California Energy Commission
Docket No. 11-AAER-2
Docket Unit
1516 Ninth Street, Mail Station 4
Sacramento, CA 95814-5504

Re: Docket Number: 11-AAER-2 (Proposed Amendments to Appliance Efficiency Regulations, 15-Day Language)

Bose Corporation Continues to Urge the CEC to Develop a Test Procedure for Small Battery Chargers that Addresses, Instead of Ignores, the Complexities Inherent in Multi-Function Devices

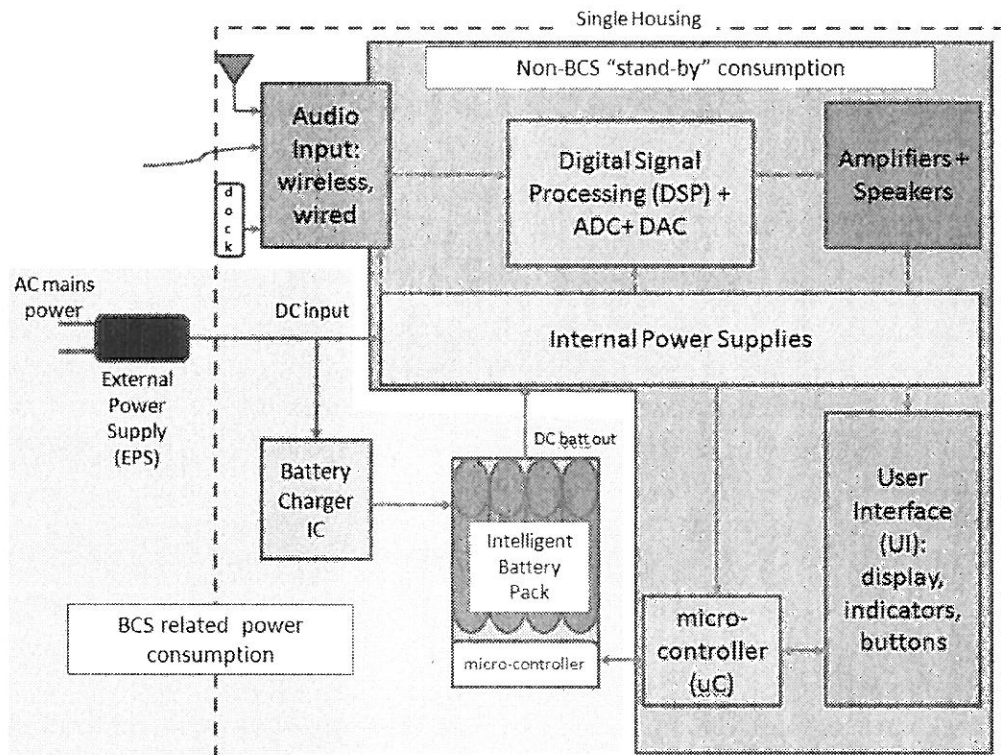
To illuminate this issue more fully, please find below a block diagram representative of several Bose audio products which will be covered by the proposed BCS regulation. While these products are primarily battery-operated portable equipment, their typical usage model also includes connection to AC main powers and operation *in situ* for a significant portion of their life cycle. This block diagram, description of the power consuming components, and usage model is similar to other portable multi-function audio products produced by other manufacturers.

Sources of BCS related power consumption:

- ☞ This encompasses the external power supply (EPS) supplying the DC voltage from AC mains power, the integrated battery charger circuit, and the “intelligent” (micro-controller based) battery pack. The latter two being integrated in a common housing and often sharing printed circuit board (PCB) space with non-BCS functions such as internal power supplies, micro-controllers (uC) or audio amplifiers. If removable at all – some are not - the battery pack requires common tools to remove.

Sources of non-BCS power consumption:

- Although the Digital Signal Processing (DSP) function is in a low power state during the product's standby mode, it does remain powered to facilitate a "quick on" experience which the consumer demands.

The micro-controller (uC) remains powered as it is responsible for monitoring user inputs and wake functions from the user interface (UI) in addition to monitoring the battery pack's micro-controller for status indicators, such as charge state and battery faults. Because these elements are powered during the product's standby power state, various internal power supplies are also "on" with resultant efficiency losses and power consumption in those internal power supplies.

Through laboratory measurements and analysis, we have observed that the non-BCS power consumption can be 10-40% of the BCS related power consumption. These non-BCS functions represent *a significant power consumption adder to the BCS measurements being taken at the AC mains power and likely will cause unintended non-compliance to the BCS limits simply because they are not considered, isolated, and addressed in the test procedure.*
